Access Compliance Report

Public Rights-of-Way

(Curb Ramps)

Intersection ID: 13538	Main Street: SOUTHWOOD_AV	Cross Street: W_PARK_AV	Location: SW
ADA ID: 6F7891DC89D0	Ramp Type: Perp	Initial Pass/Fail: Pass	Overall Compliance: No
Severity Score: 25			
Codes/Mitigation Info/Possible Solution		Field Measurements/Component Compliance

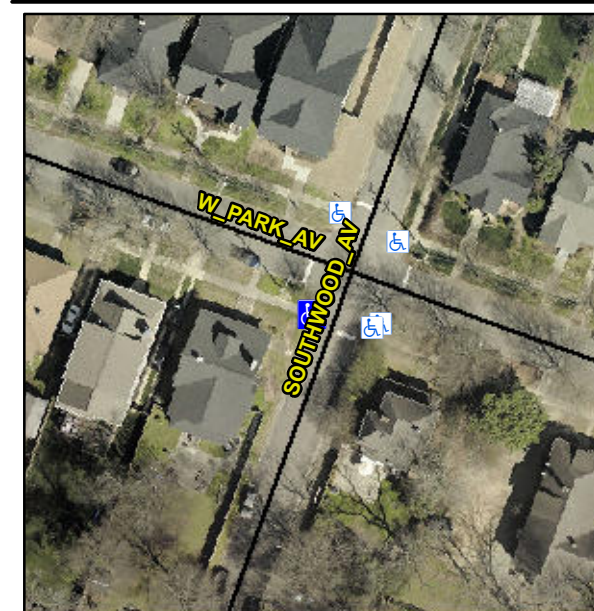
**Not Found, R304.2.2-Perp, R304.3.2-
Para, R305, R302.7.2, R304.5.3**

Compliance	Description	Data	Compliance	Description	Data
N/A	Ramp Length (in)	40.0	Yes	Ramp Slope (%)	7.3
Yes	Ramp Width (in)	60.0	Yes	Ramp XSlope (%)	1.0
N/A	Flare Type LT	None	N/A	Flare Type RT	N/A
N/A	Flare Slope LT (%)	N/A	N/A	Flare Slope RT (%)	N/A
N/A	Flare Traversable LT?	N/A	N/A	Flare Traversable RT?	N/A
Yes	Landing Length (in)	48.0	No	DWS Provided?	No
Yes	Landing Width (in)	59.0	N/A	DWS Contrast?	No
No	Landing Slope (%)	2.3	N/A	DWS Length (in)	N/A
Yes	Landing X Slope (%)	1.2	N/A	DWS Full Width?	No
N/A	Landing Curb? (Y/N)	No	N/A	DWS Offset (in)	N/A
N/A	Shared Landing?	No			
Yes	Gutter Ponding?	No	Yes	Gutter Slope (%)	3.1
No	Gutter Lip Ht (in)	3.0	No	Gutter X Slope (%)	5.2
N/A	Painted X Walk1?	No	N/A	Painted X Walk2?	N/A
	X Walk 1 Direction	To SE		X Walk 2 Direction	N/A
N/A	X Walk 1 Width (in)	N/A	N/A	X Walk 2 Width (in)	N/A
	X Walk 1 Slope (%)	1.8		X Walk 2 Slope (%)	N/A
	X Walk 1 X Slope (%)	4.1		X Walk 2 X Slope (%)	N/A

N/A	Ramp inside XWalk1?	N/A	N/A	Ramp inside XWalk2?	N/A
	Road Slope (%)	N/A	N/A	Clear Space?	Yes
	Road X Slope (%)	N/A	N/A	Clear Space to XWalk (in)	N/A
Yes	Any Obstructions?	No	Yes	Storm Grate/Utility Hazard?	No
	Obstruction Type			Storm Grate/Utility Type	
		N/A			N/A
			Yes	Surface Condition? (G/P)	Good

**Remove & Replace Entire Ramp.
Remove & Replace Gutter.**
